QUALITY FEEDBACK REPORT

NC Report No	QFR/09/01	Report Date	26-Sep-22
Part Name	Ball race	Part no / Rev No.	520AM01202
Supplier Code	100264	NC Reported Date :	23-Sep-22
Supplier Name	M/S Sai Industries	Countermeasure Required By :	26-Sep-22

1. Problem Description

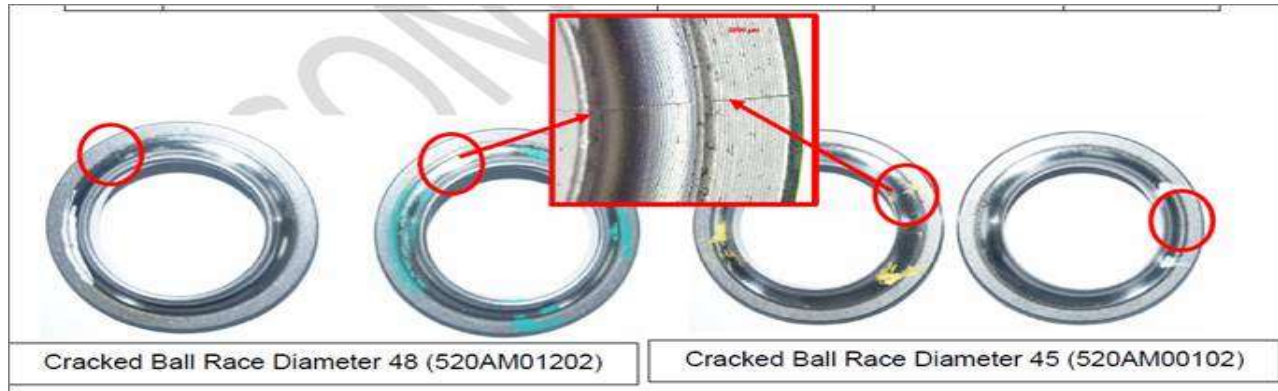
Details of Non Conformity :	Ball Race crack during assly.			Qty	60
Detection Stage	Receipt	ETPL Testing	In-Process	Customer	Warranty
Problem Severity	Safety	Function	ETL -Fitment	Customer -Fitment	Aesthetic
Report Type	Non-Repeatative		Repeatative		
Photograph / Sketch:

Probable Causes	Case 1	Case 2	Case 3
Why 1	Ball Race crack during assly.	Ball Race crack during assly.	
Why 2	In Final Inspection above defect not detect.	In destructive testing case depth and core harness is above specification.	
Why 3	Due to destructive testing parts not verify before frequency.	Case depth found 1.20 and core hardness found 57RC.	
Why 4	Destructive testing frequency not adequate.Currently is once In Six Month.	In heat treatment cycle not followed by supplier.	
Why 5		Carburising cycle time and quenching temperature excess than specification observed.	
Root Cause	Carburising cycle time and quenching temperature excess than specification found.

Sr. No.	Immediate Action Taken	Target Date	Responsibility
1	Verified in ETL found 60 nos.crack during assly in 1200 Nos.After received in Sai will be scrapped.In Logistic and in house No finish stock verify for crack.	23.09.2022	Deepak
2	Information has been given to heat treatment supplier for minimize case depth and core hardness.	24.09.2022	Tajane

Sr. No.	Corrective / Preventive Action Taken	Target Date	Responsibility
1	Revised heat treatment control plan for to minimize Carburizing cycle time and quenching low temperature implemented . Carburising cycle(soaking) time changed 70 to 60 Minutes.Quenching temperature changed 860 to 850°C.Trial conducted for one lot & supplied with green dot mark on o/d 48 as identification.	25.09.2022	SupplierTajane
2	One piece test quarterly in NABL lab for Case depth & Core Hardness started. Corrected one lot 500 nos.supplied to ETL with green dot on o/d 48 as a indetification mark.NABL lab report submitted along with lot.	26.09.2022	Tajane
3			
4			
5
